## STAR ONLINE PUBLICATION

**Case Number: S2509000001 Rev. A**

**Symptom/Vehicle Issue:** Engine Rattle Noise

**Repair Procedure:** \*\* ATTENTION: THE REPAIR PROCEDURE BELOW IS A MODIFICATION TO THE CURRENTLY ISSUED SERVICE PROCEDURE IN SERVICE LIBRARY \*\*

**DO NOT USE** (#2 in pic below)

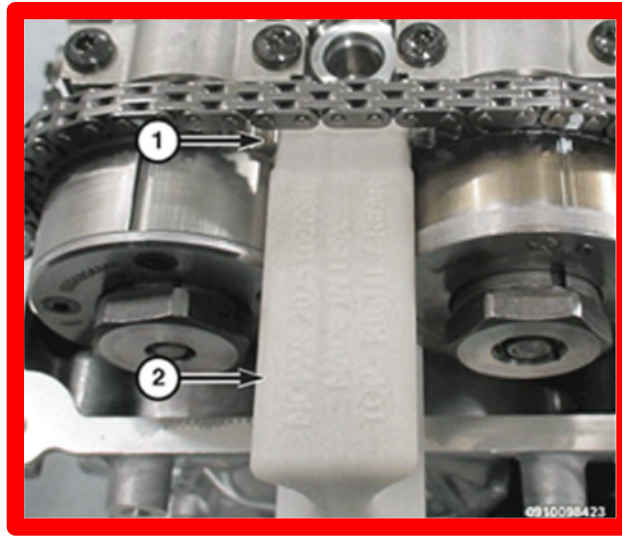
1. **DO NOT** use the camshaft phaser holding tool (Tool # 2025102090) while torquing the OCVs.

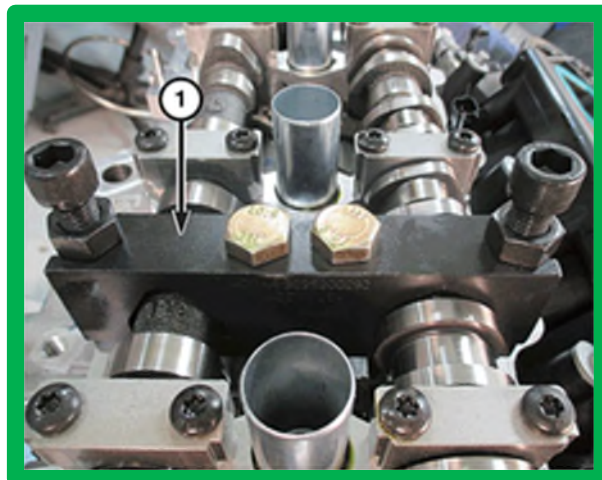
2. **DO** use the cam holding tool (Tool #2025200090) while torquing the OCVs.
